Access Compliance Report

Public Rights-of-Way

Intersection ID: 19542	Main Street: PROVIDENCE_RD	Cross Street: STRAWBERRY_HILL_DR	Location: E
ADA ID: 3F6DE8EAFCC2	Ramp Type: PerpDiag	Initial Pass/Fail: Fail	Overall Compliance: No
Codes/Mitigation Info/Possible Solution		Field Measurements/Component Compliance	
Severity Score: 26.25

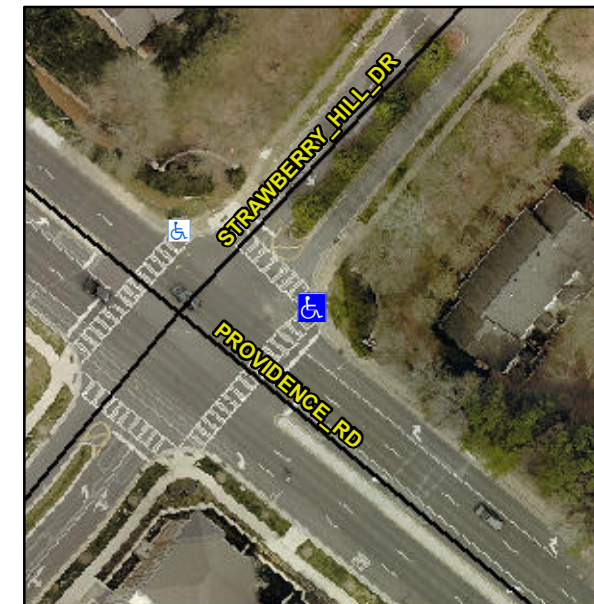
Not Found, R304.2.2, R304.5.3

Compliance	Description	Data	Compliance	Description	Data
N/A	Ramp Length (in)	73.0	No	Ramp Slope (%)	12.8
Yes	Ramp Width (in)	48.0	No	Ramp XSlope (%)	4.6
N/A	Flare Type LT	N/A	N/A	Flare Type RT	N/A
N/A	Flare Slope LT (%)	N/A	N/A	Flare Slope RT (%)	N/A
N/A	Flare Traversable LT?	N/A	N/A	Flare Traversable RT?	N/A
N/A	Landing Length (in)	N/A	N/A	DWS Provided?	N/A
N/A	Landing Width (in)	N/A	N/A	DWS Contrast?	N/A
N/A	Landing Slope (%)	N/A	N/A	DWS Length (in)	N/A
N/A	Landing X Slope (%)	N/A	N/A	DWS Full Width?	N/A
N/A	Landing Curb? (Y/N)	N/A	N/A	DWS Offset (in)	N/A
N/A	Shared Landing?	N/A			
N/A	Gutter Ponding?	N/A	N/A	Gutter Slope (%)	N/A
N/A	Gutter Lip Ht (in)	N/A	N/A	Gutter X Slope (%)	N/A
N/A	Painted X Walk1?	No	N/A	Painted X Walk2?	No
	X Walk 1 Direction	To NW		X Walk 2 Direction	To SW
N/A	X Walk 1 Width (in)	N/A	N/A	X Walk 2 Width (in)	N/A
	X Walk 1 Slope (%)	1.2		X Walk 2 Slope (%)	3.9
	X Walk 1 X Slope (%)	3.2		X Walk 2 X Slope (%)	0.7

Remove & Replace Curb Ramp With Two New Directional Ramps or Equivalent.
